Customer Service Bulletin

SLM Electronics, Inc. Saint Louis, Missouri

CSB0015

Component tolerances of transistors may cause the unit to produce audible distortion after use.

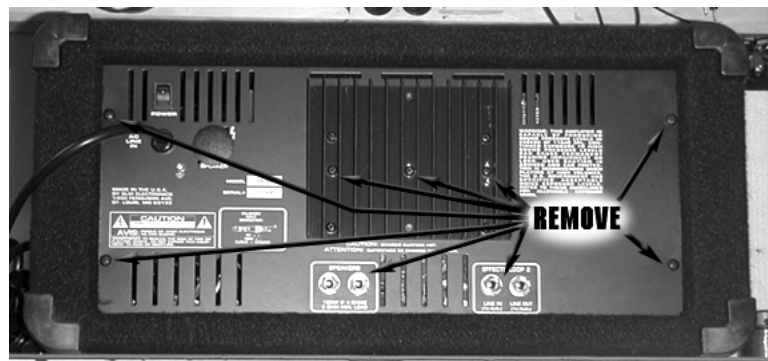
1. Tools/parts needed: #2 Phillips screwdriver, 1/2" nut driver, wire cutters, soldering iron and solder, solder wick or desoldering tool, 56pF capacitor (SLM Electronics part #10A560-21).
2. Unplug the unit.
3. Remove the three middle screws from the heatsink, the four rear panel mounting screws, and the four nuts from the rear panel jacks (see photo below).

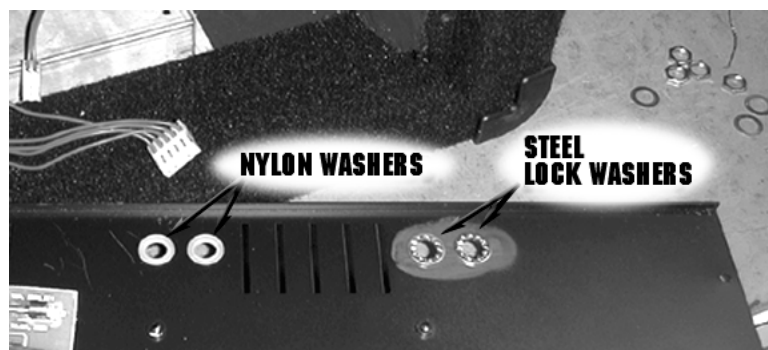
5. Lay the rear panel face down. Avoid contact with the heatsink compound! Turn the PCB over (component side up) and set the washers from the 1/4" jacks aside.
6. Locate C5 (see photos below). Unsolder and discard the existing capacitor and replace it with the 56pF capacitor. Clip and remove the excess leads and solder the capacitor into place.
